## 5.3 Responses to Submissions

### 5.3.1 Private Submitter 5

**Figure 5.3-A PM<sub>10</sub> concentrations recorded at Balgowan (µg/m<sup>3</sup>) and adopted background concentration**

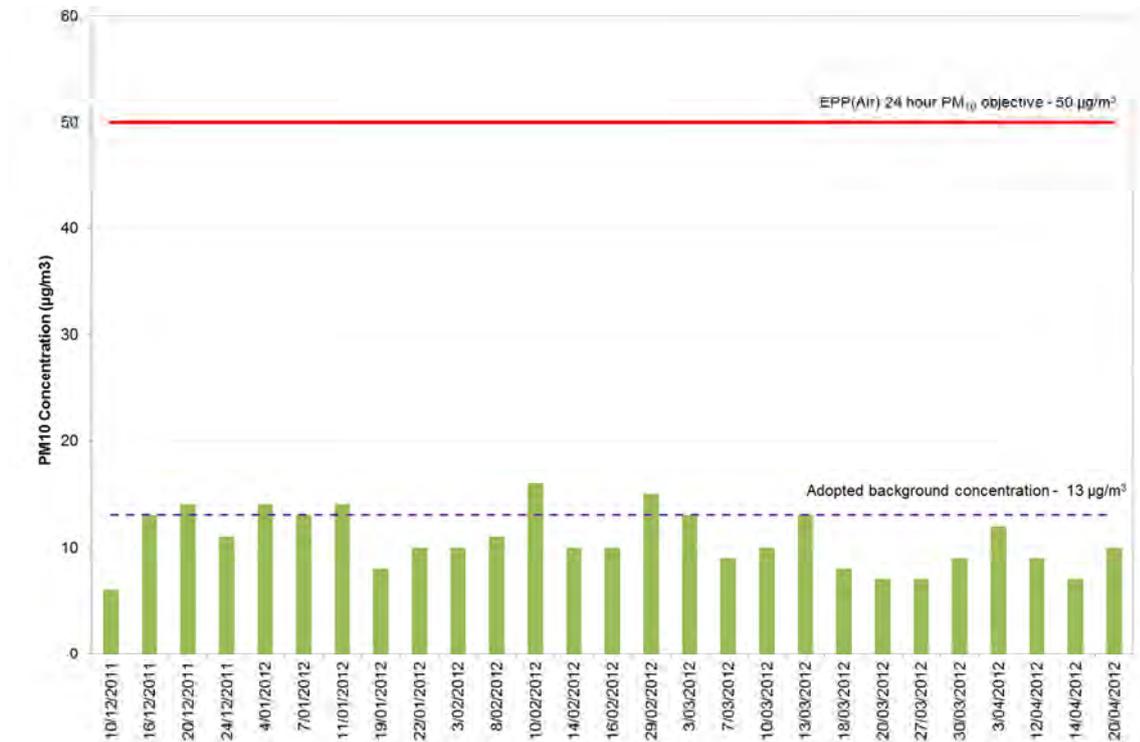
The 2011/2012 period contained the most amount of air quality monitoring data to undertake a validation study. NAC conducted a monitoring campaign measuring PM<sub>10</sub> at Balgowan located approximately 2 km northwest of the Mine. For the purposes of the validation study presented in **Appendix G.6.6** of the draft EIS, a 70<sup>th</sup> percentile 24 hour average PM<sub>10</sub> from the Balgowan data (13 µg/m<sup>3</sup>) presented has been adopted as the background concentration. EPA Victoria (2007) recommends adopting the 70<sup>th</sup> percentile pollutant concentration to determine cumulative impacts.

The PM<sub>10</sub> concentrations recorded at Balgowan are presented in **Figure 5.3-A**. The adopted background concentration for the validation study is also presented in **Figure 5.3-A**. Dust monitoring results recorded at Balgowan in 2011/2012 are consistent with long term particulate monitoring results undertaken by NAC. The adopted background PM<sub>10</sub> concentration of 13 µg/m<sup>3</sup> is considered appropriate to determine potential cumulative impacts of current mining operations.

**Figure 5.3-B Ideal size distribution of particle mass**

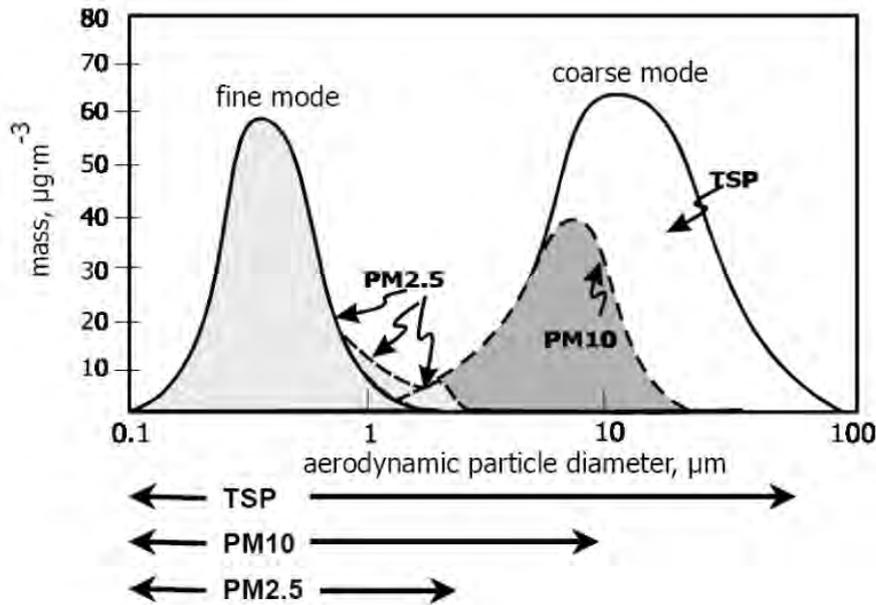
- particles with an equivalent aerodynamic diameter greater than 10  $\mu\text{m}$ ;
- particles with an equivalent aerodynamic diameter between 2.5 and 10  $\mu\text{m}$ ; and
- particles with an equivalent aerodynamic diameter less than 2.5  $\mu\text{m}$ .

An ideal size distribution of airborne particulates by mass is presented in **Figure 5.3-B**. The coarse particles are produced through mechanical processes with potential sources including wind-blown dust and mining operations. Particulates generated from mining operations of the revised Project are predominantly coarse.
